**In the Matter of the Request for a Conditional Use Permit for Warehouse, Including Distribution, Use on 15.97-Acres of Land in the M-E Zoning District at 1085 S. Ten Mile Rd., by Adler Industrial.**

**Case No(s). H-2024-0018**

## COMMUNITY DEVELOPMENT DEPARTMENT REPORT

APPLICANT: Adler Industrial  
 SUBJECT: H-2024-0018  
 TMW - CUP

# D. Landscape Plan (date: 6/11/2024)

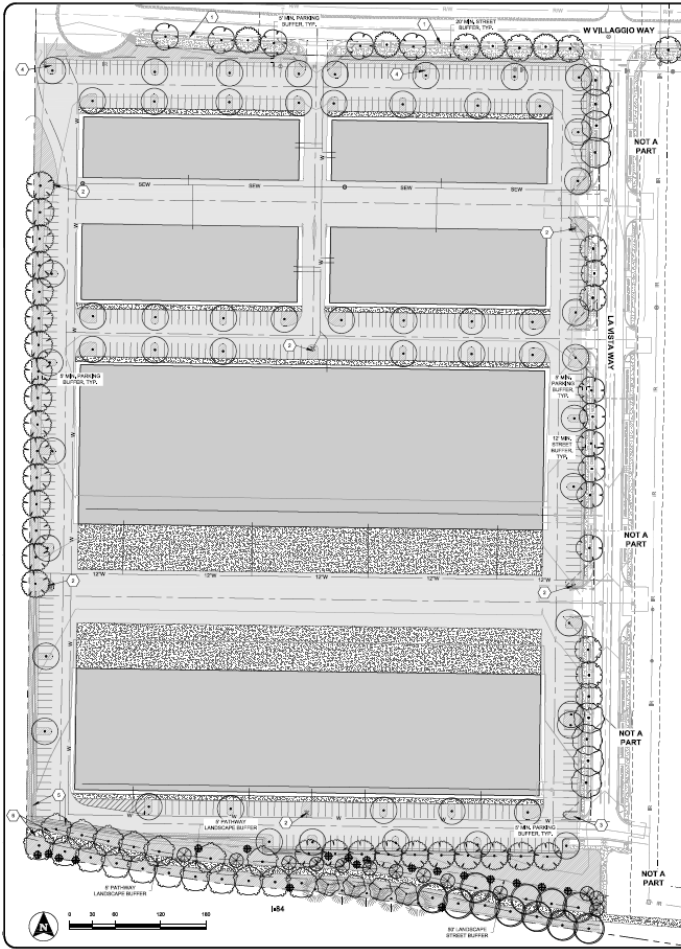
**The site/landscape plans submitted with the Certificate of Zoning Compliance should be revised to comply with these standards.**

- iv. Tree preservation  
There are some existing trees on the southwest portion of this site. The landscape plan includes a tree mitigation schedule that depicts (32) 2-inch caliper trees but doesn't include how many caliper inches are being removed; **the plan submitted with the Certificate of Zoning Compliance application should include detailed information that demonstrates compliance with the standards listed in UDC [11-3B-10C.5](#).**

- v. Storm integration  
Stormwater integration on the site is required to comply with the standards listed in UDC [11-3B-11C](#).
  - vi. Pathway landscaping  
Landscaping is required along the multi-use pathway within the street buffer along I-84 along the southern boundary of the site in accord with the standards listed in UDC [11-3B-12C](#). **A mix of trees, shrubs, lawn and/or vegetative groundcover should be provided; the landscape plan should be revised to include shrubs as required.**

- c. Include linear feet of perimeter buffers in the Parking Lot Perimeter Tree Schedule.  
*Note: The width of the western perimeter buffer isn't the same between the site and landscape plans and the full perimeter buffer isn't depicted on the site plan – revise accordingly.*

- d. Include tree mitigation information on the plan that demonstrates compliance with the standards listed in UDC [11-3B-10C.5](#).
  - e. Include shrubs and lawn or vegetative groundcover along with the trees within the landscape strips along the multi-use pathway within the street buffer along the southern boundary of the site adjacent to I-84 in accord with the standards listed in UDC [11-3B-12C](#).
